Cockle Bay Park Redevelopment State Significant Development Application (SSD DA) Stage 2

MOD-1 Envelope Modifications Proposal

Prepared for DPT Operator Pty Ltd and DPPT Operator Pty Ltd
01.11.2021

Market Street Bridge connection

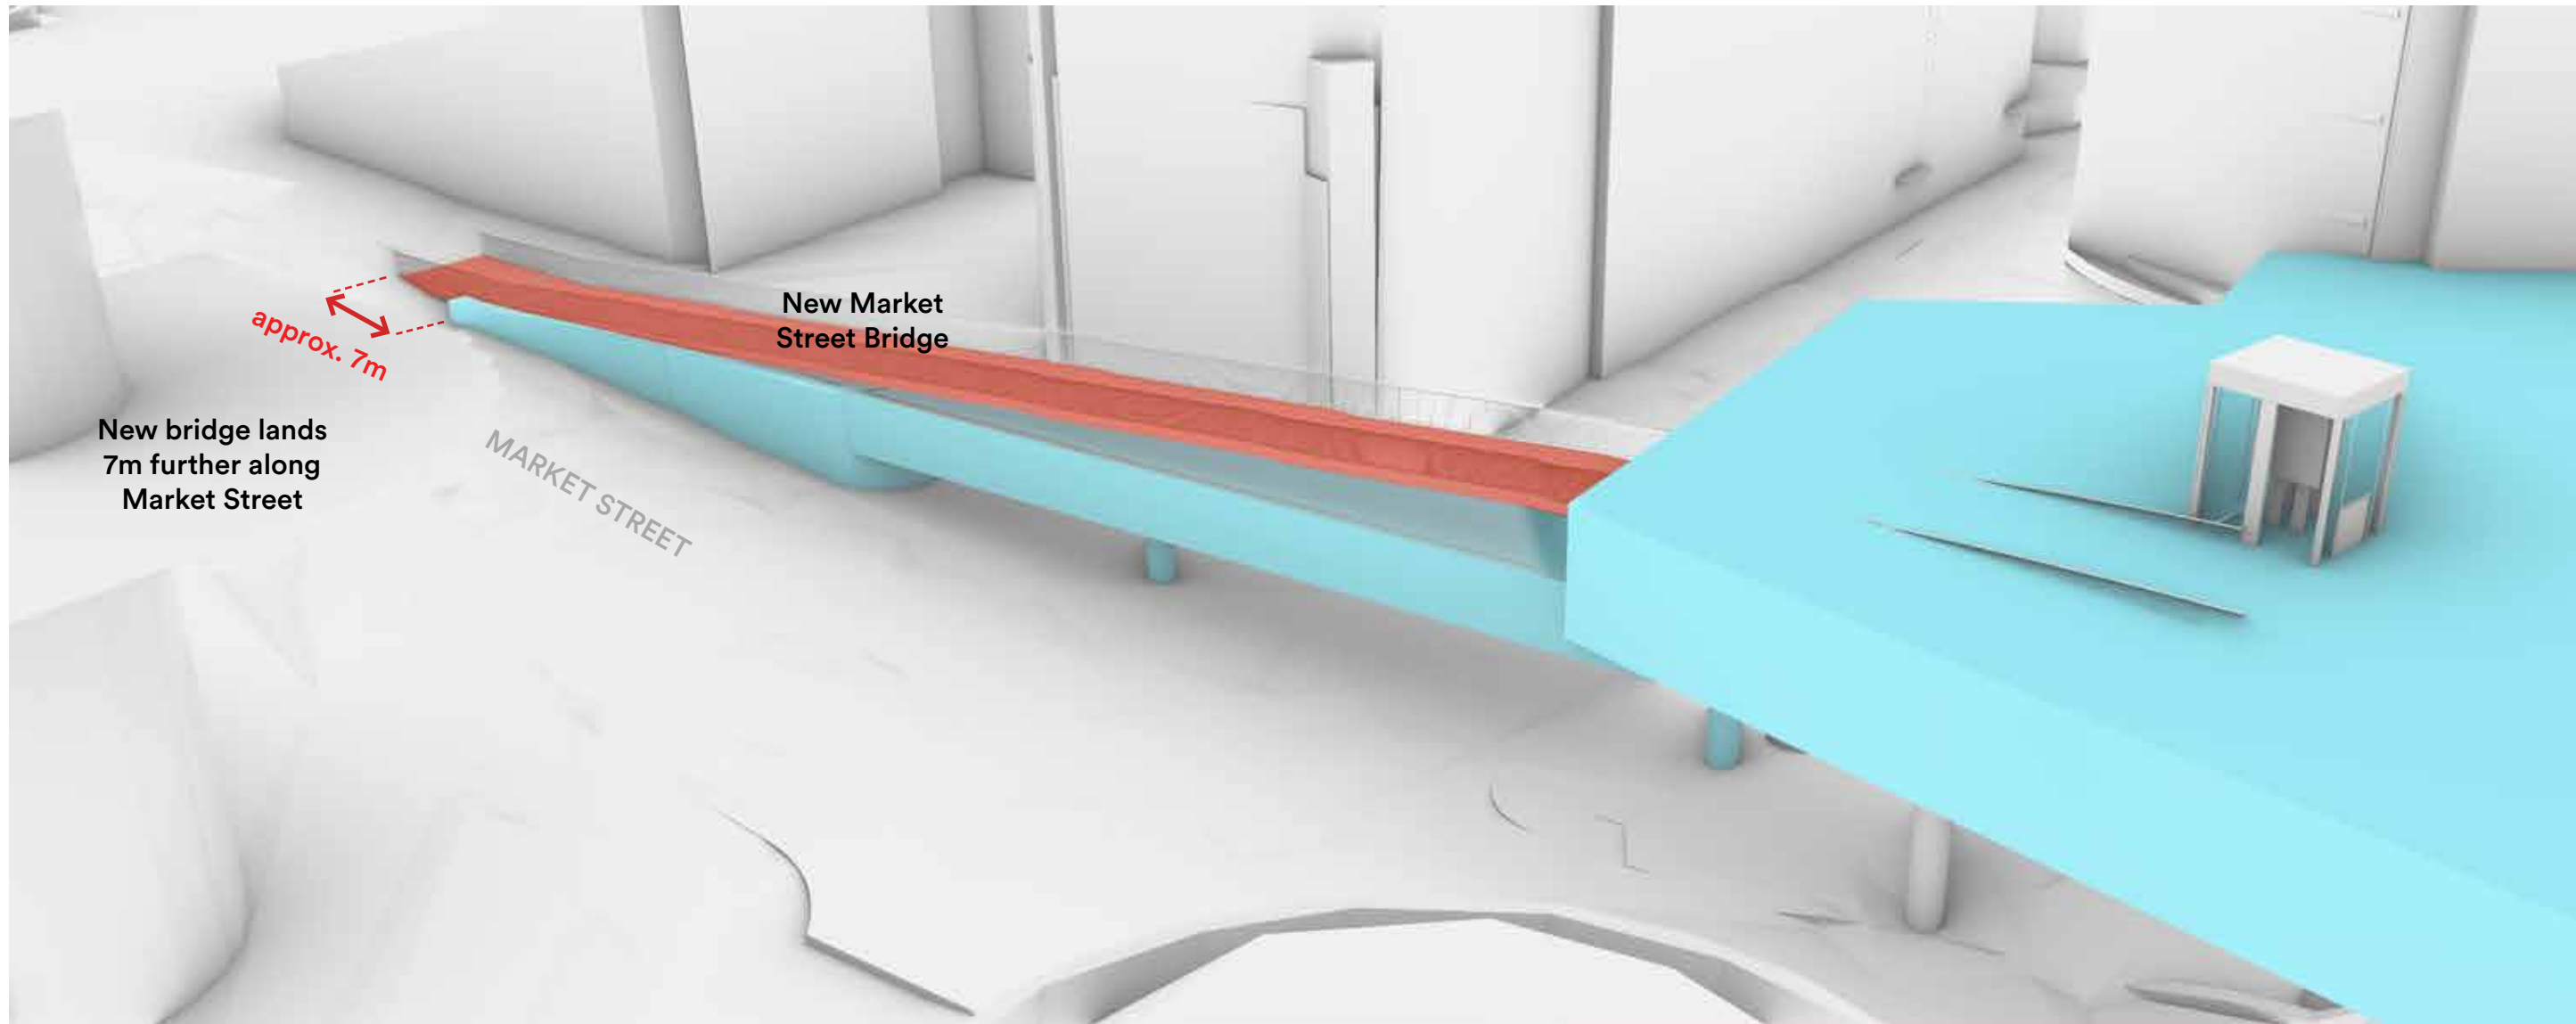
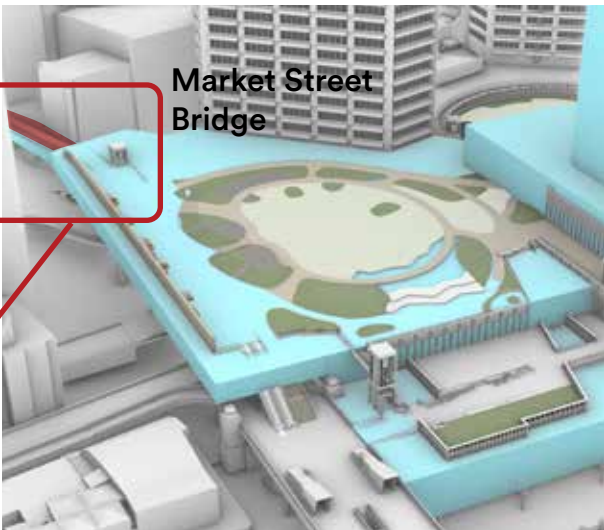
In order to provide equitable access from Market Street to landbridge level and ensure clearance requirement above the Western distributor, the design of Market Street Bridge has been refined and updated. The bridge extends further along Market Street and slopes up to a higher level to connect to the landbridge and allow passage for vehicles below. The new bridge will be DDA compliant.

Sussex Plaza connection

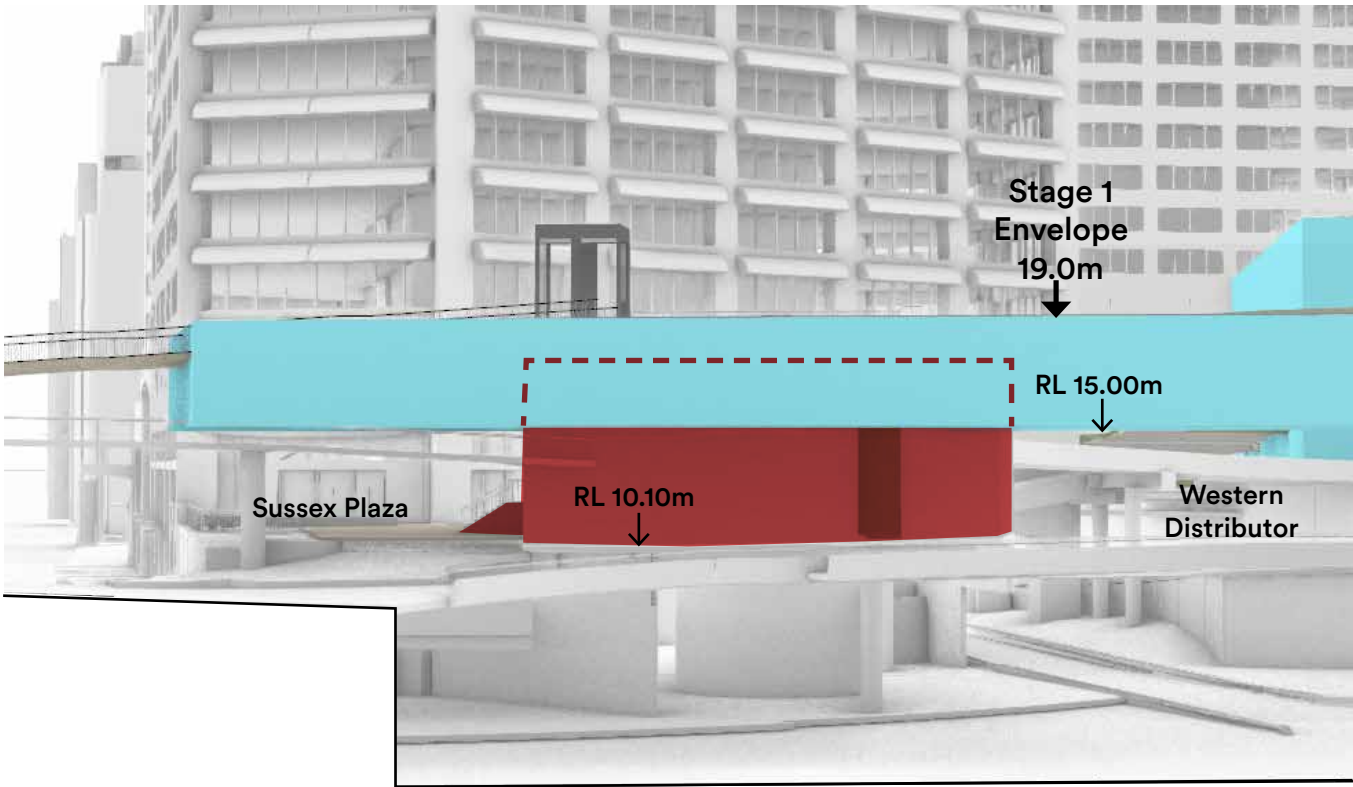
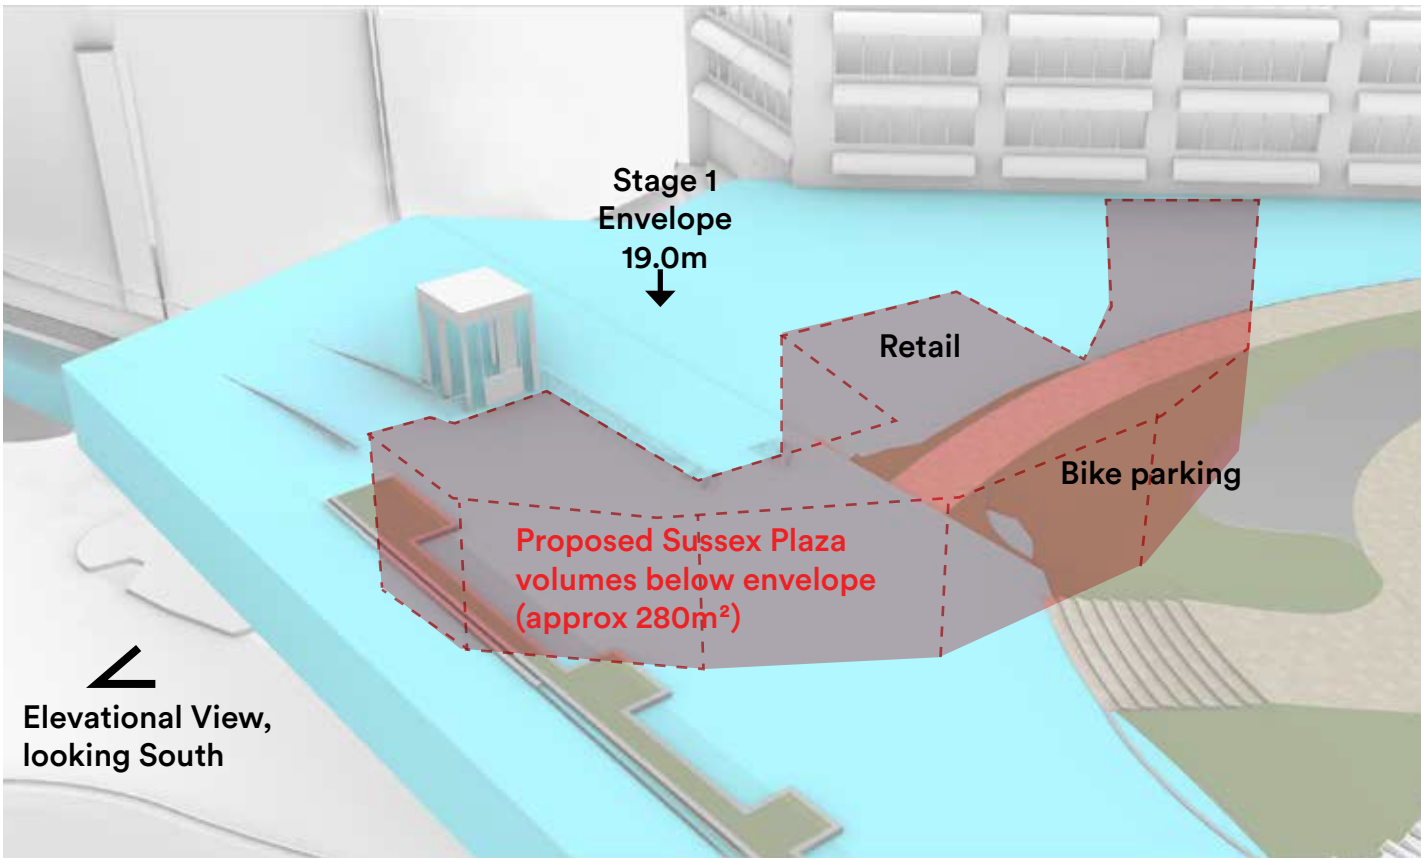
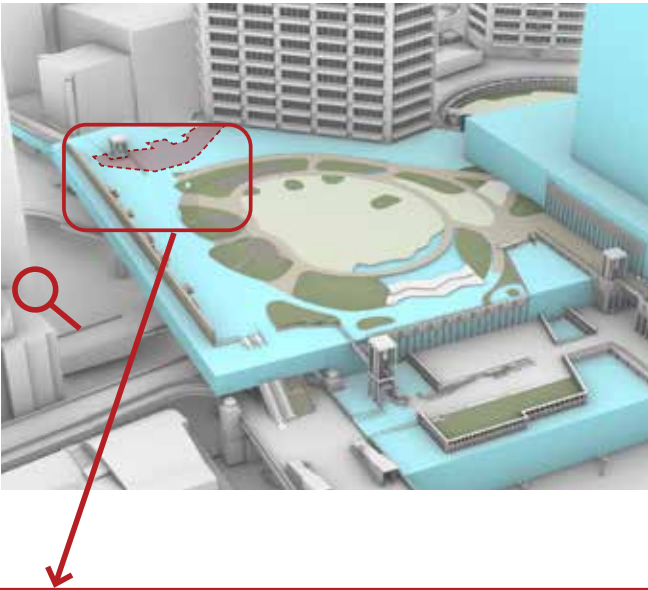
The updated scheme is proposed to include the existing retail asset within the plaza at the corner of Market Street and Sussex Street, which forms part of the site but was not previously included within the proposed development. Volumes extend below the landbridge of the Stage 1 envelope, connecting to Sussex Plaza below. Stairs, escalators and a lift provide equitable access to the landbridge from Sussex Plaza. The proposal seeks to utilise and refine an existing retail space to continue to activate the Sussex Street frontage of the site, as a gateway to the precinct.

Crescent Garden

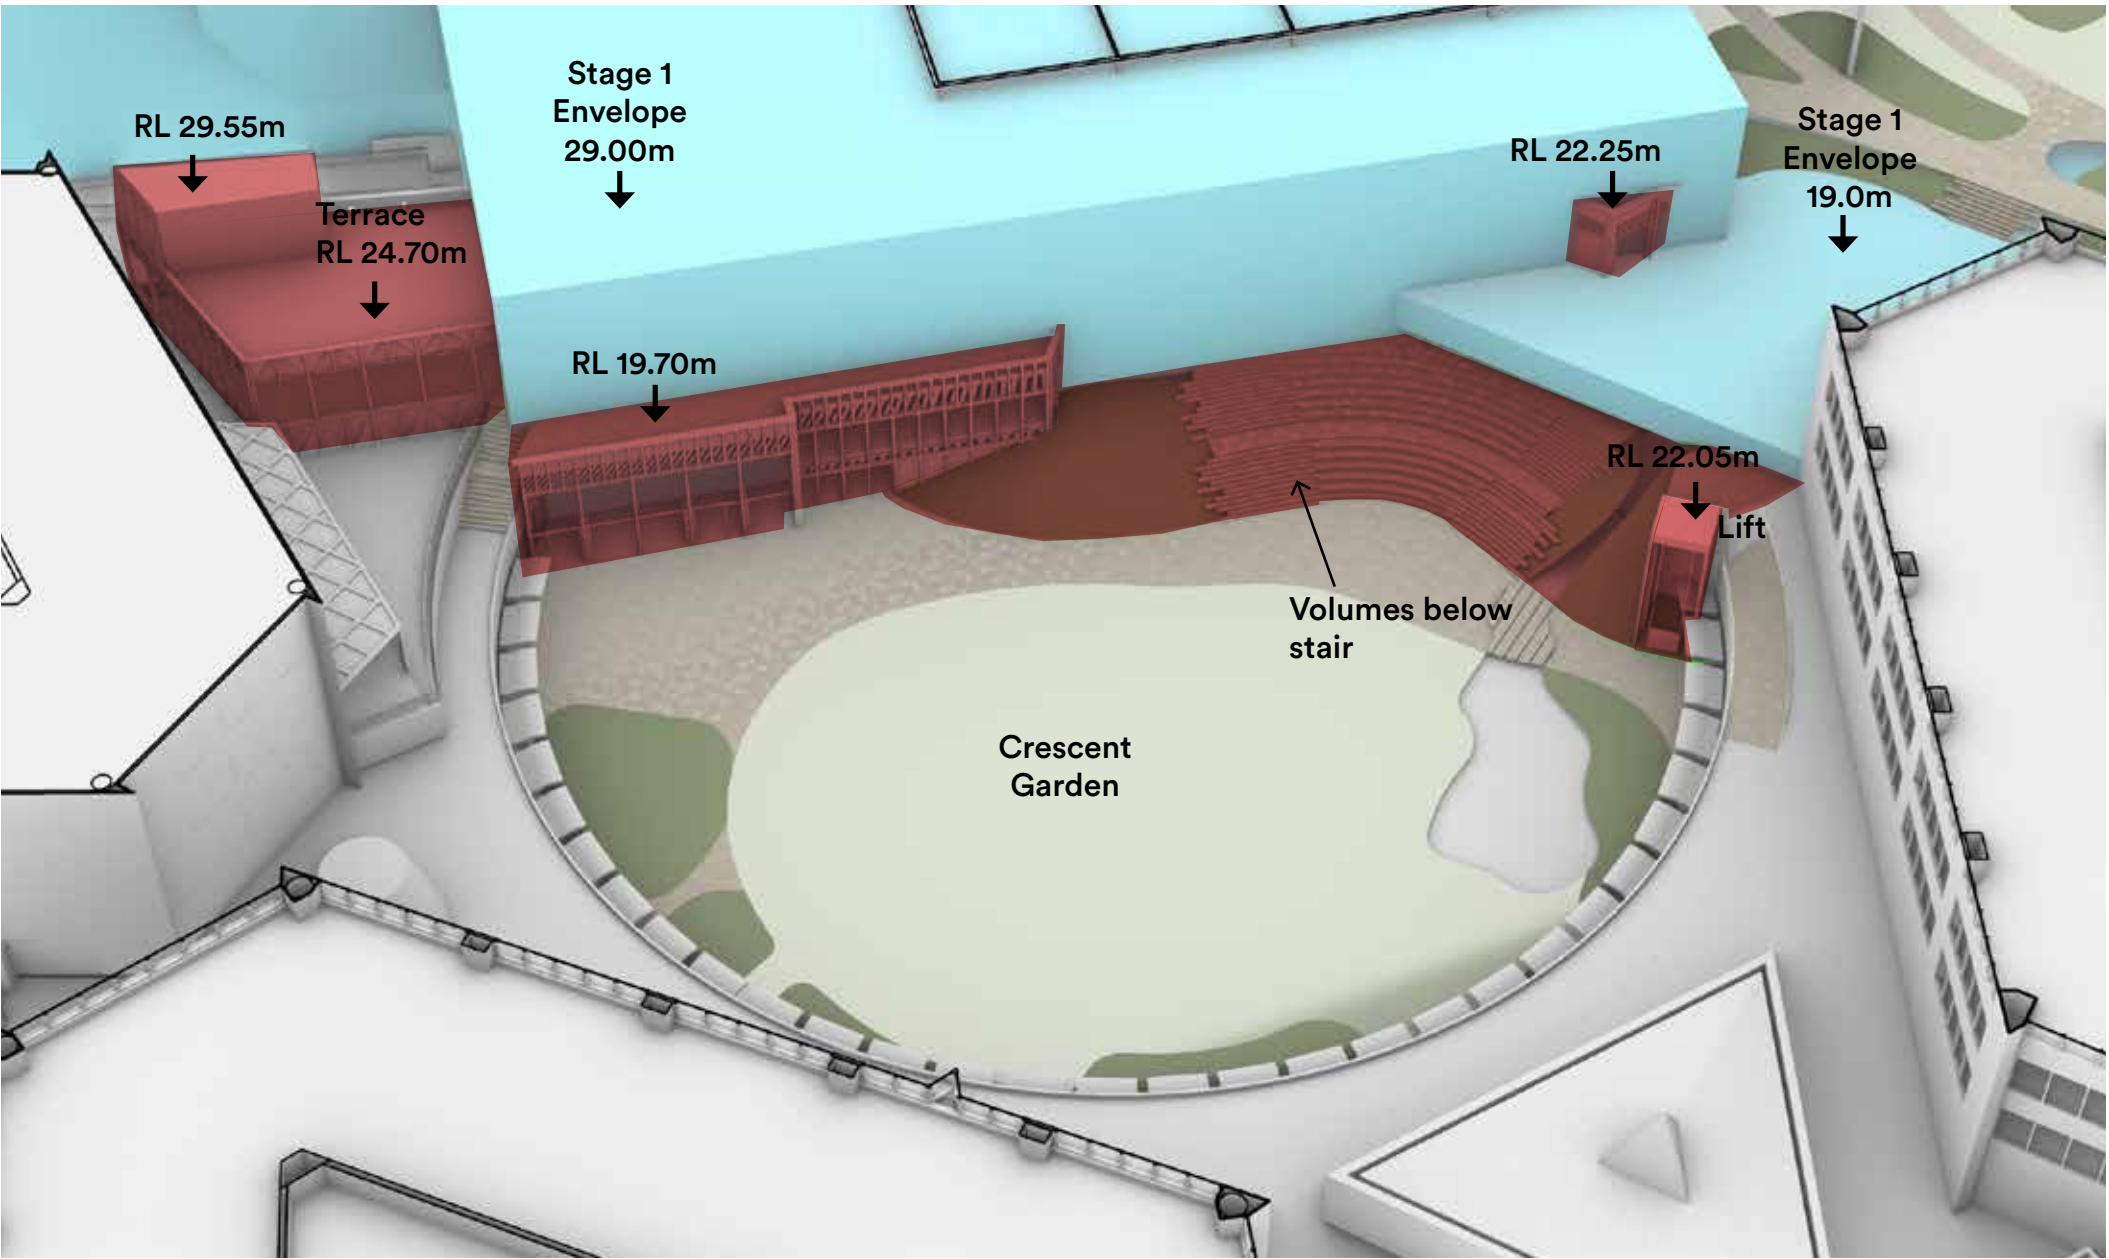
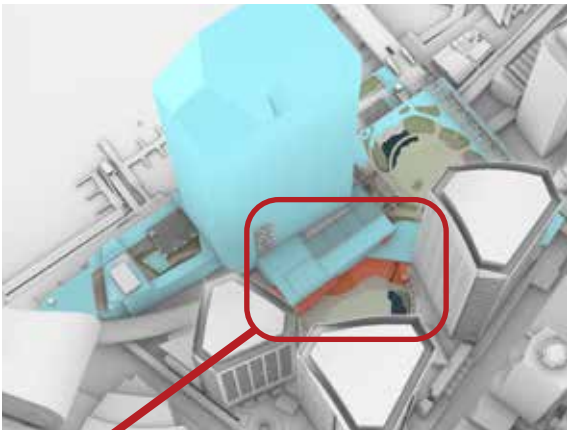
The updated scheme is proposed to include connections from the new Tower to the Crescent Garden open space and the Darling Park precinct.

The configuration of these volumes enables seamless integration with the existing Darling Park built form and brings a village typology of volumes to crescent garden.

The setting out arrangement and extents of the volumes has been guided by the structural grid of the existing building below. It will also achieve the natural

Tower (East)

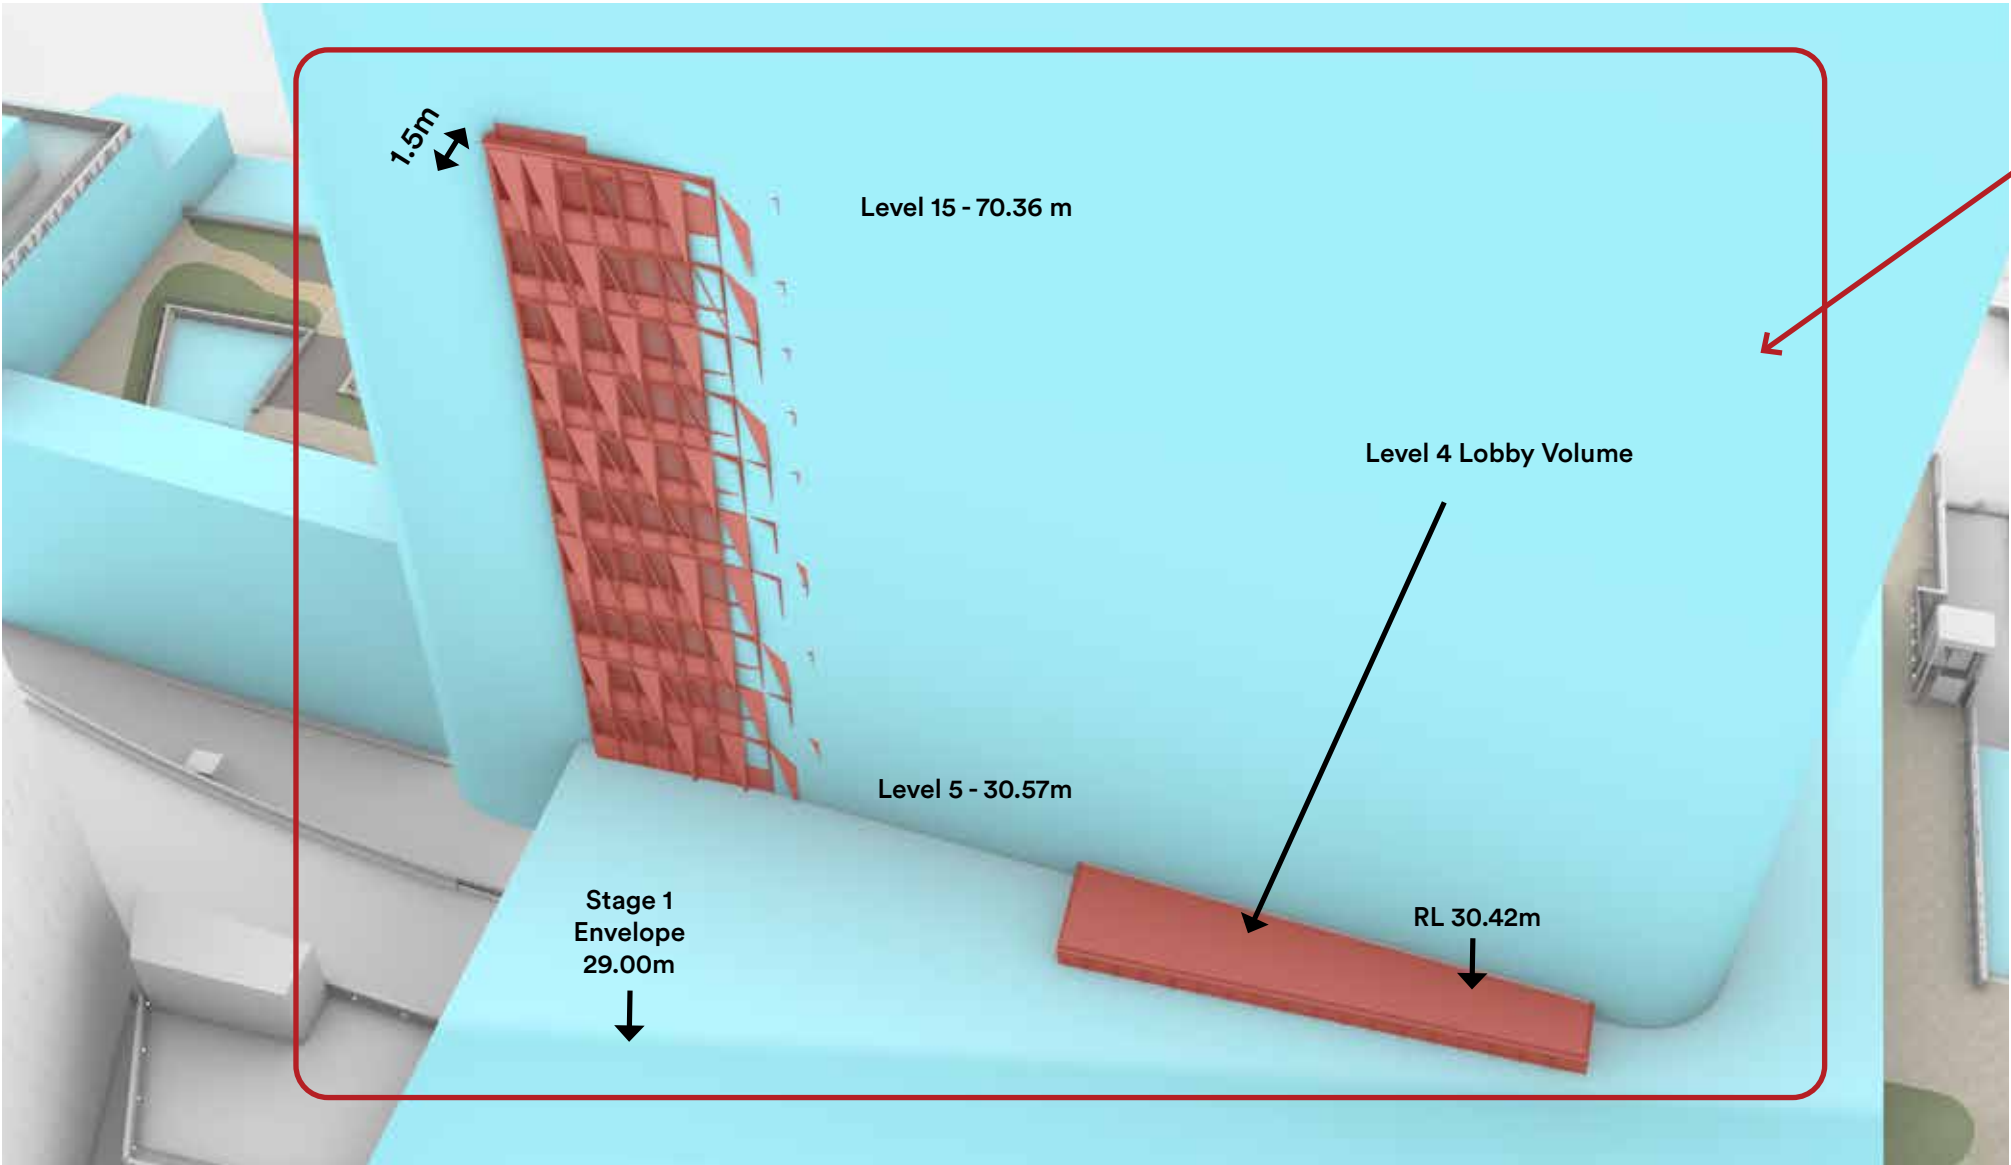
While the concurrent Stage 2 SSD DA built form has pulled back from the envelope in many areas. The building envelope is required to be modified on the low-rise eastern facade to account for an adjusted footprint of the building to provide better tower articulation, and to optimise modulation of the facade elements.

A portion of the Tower on Level 4 breaches the envelope to the North-east - a result of the raised level of the Tower Lobby on Level 3 below. This envelope breach is deemed to be minor and appropriate.

Outside the envelope:
1m - measured to the facade's glass line
1.375mm - including facade's shading elements
